SERVICE BULLETIN

OIL - INCORPORATE REVISED NO.4 AND NO.5 BEARING OIL SCAVENGE TUBE ASSEMBLIES - CATEGORY CODE 3 - MOD.ENG-79-0001

(1) Aircraft: Airbus A320

(2) Engine: V2500-A1 Engine Serial No.s V0014, V0015, V0016 and V0017

No.4 Scavenge Tube Fig.1

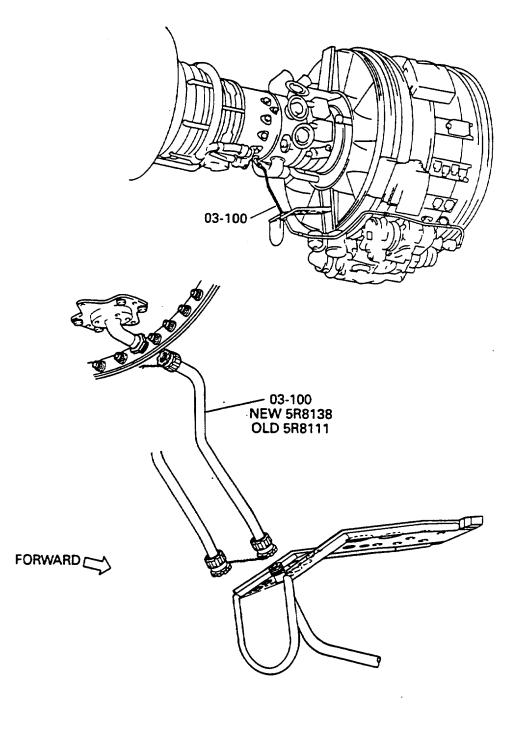
No.4 Scavenge Tube, Diffuser Case to Bifurcation Panel, is too short. This can cause unwanted load to No.4 Scavenge Tube, No.4 Bearing Compartment that may break the No.4 Scavenge Tube.

(1) No.4 Scavenge Tube is lengthened to fit properly.

- (2) Install PN 5R8138 No.4 Scavenge Tube (03-100, Figure 1
 - (a) Put a new No.4 Scavenge Tube in position on the engine.

(b) Torque nuts to 525 to 625 lbfin (59,32 to 70,61 Nm) and safety with CoMat O2-126 lockwire.

NOTE: Old No.4 Scavenge Tube was fixed to the Raceway (71-52-50, 05-100) at its tube lug. New No.4 Scavenge Tube does not need to be fixed. See Figure 2.

No.5 Scavenge Tube Fig.2

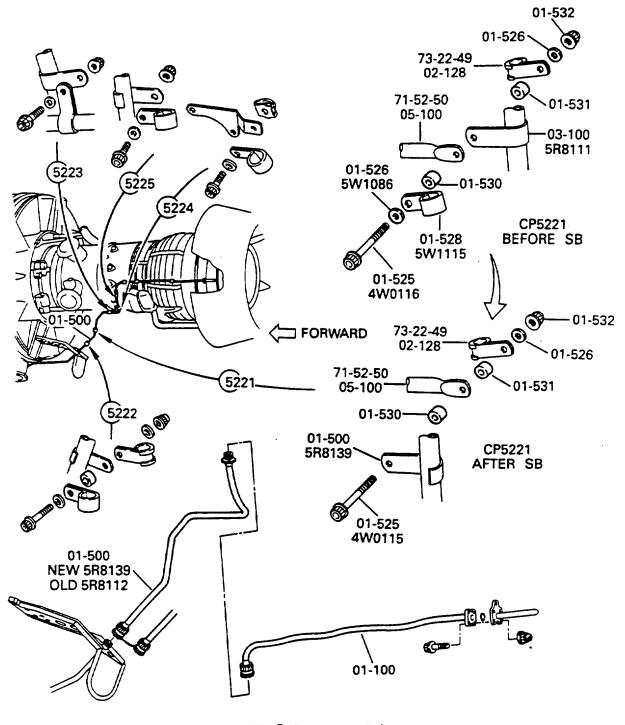
(2) Clamping Points of No.4 Scavenge Tube and No.5 Scavenge Tube are relocated.

- B. Removal Instructions
 - (1) Remove PN 5R8112, No.5 Scavenge Tube (01-500), Figure 2
 - (a) Cut lockwire.
 - (b) Remove bolts, washers, spacers and clips at the clipping positions 5221, 5222, 5223, 5224 and 5225.
 - (c) Loosen nuts of tubes.
 - (d) Remove No.5 Scavenge Tube from the engine.
 - (2) Remove PN 5R8111, No.4 Scavenge Tube (03-100), Figure 1
 - (a) Cut lockwire.
 - (b) Loosen nuts of tube (2 off).
 - (c) Remove No.4 Scavenge Tube from the engine.
- C. Installation Instructions
 - (1) Install PN 5R8139, No.5 Scavenge Tube (01-500), Figure 2
 - (a) Put new No.5 Scavenge Tube in Position on the engine.
 - (b) Torque nuts to 375 to 425 lbfin (42,37 to 48,02 Nm) and safety with CoMat 02-126 lockwire.
 - (c) Install clips, clip nuts, spacers, washers and bolts at the clip positions 5221, 5222, 5223, 5224 and 5225. Torque bolt to 30 lbfin (3,39 Nm).

NOTE: Old No.5 Scavenge Tube was fixed with the clip (O1-528). New No.5 Scavenge Tube is fixed at newly added tube lug.
